Access Compliance Report

Public Rights-of-Way

Intersection ID: 44295	Main Street: PEACHWOOD_DR	Cross Street: ROCKWOOD_RD	Location: SE
ADA ID: 68E44E361F97	Ramp Type: PerpDiag	Initial Pass/Fail: Fail	Overall Compliance: No
Codes/Mitigation Info/Possible Solution		Field Measurements/Component Compliance	
Severity Score: 10

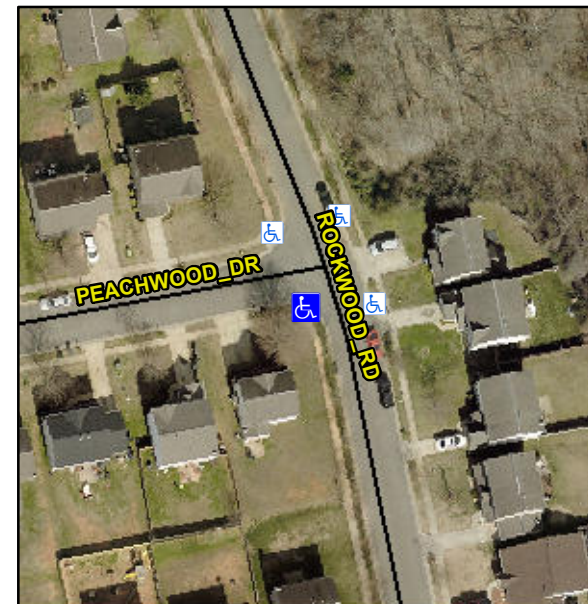
Not Found, R304.5.1, R304.5.3

Compliance	Description	Data	Compliance	Description	Data
N/A	Ramp Length (in)	45.0	Yes	Ramp Slope (%)	7.1
No	Ramp Width (in)	41.5	No	Ramp XSlope (%)	2.1
N/A	Flare Type LT	N/A	N/A	Flare Type RT	N/A
N/A	Flare Slope LT (%)	N/A	N/A	Flare Slope RT (%)	N/A
N/A	Flare Traversable LT?	N/A	N/A	Flare Traversable RT?	N/A
N/A	Landing Length (in)	N/A	N/A	DWS Provided?	N/A
N/A	Landing Width (in)	N/A	N/A	DWS Contrast?	N/A
N/A	Landing Slope (%)	N/A	N/A	DWS Length (in)	N/A
N/A	Landing X Slope (%)	N/A	N/A	DWS Full Width?	N/A
N/A	Landing Curb? (Y/N)	N/A	N/A	DWS Offset (in)	N/A
N/A	Shared Landing?	N/A			
N/A	Gutter Ponding?	N/A	N/A	Gutter Slope (%)	N/A
N/A	Gutter Lip Ht (in)	N/A	N/A	Gutter X Slope (%)	N/A
N/A	Painted X Walk1?	No	N/A	Painted X Walk2?	No
	X Walk 1 Direction	To W		X Walk 2 Direction	To N
N/A	X Walk 1 Width (in)	N/A	N/A	X Walk 2 Width (in)	N/A
	X Walk 1 Slope (%)	1.2		X Walk 2 Slope (%)	1.0
	X Walk 1 X Slope (%)	1.1		X Walk 2 X Slope (%)	0.3

Remove & Replace Curb Ramp With Two New Directional Ramps or Equivalent.
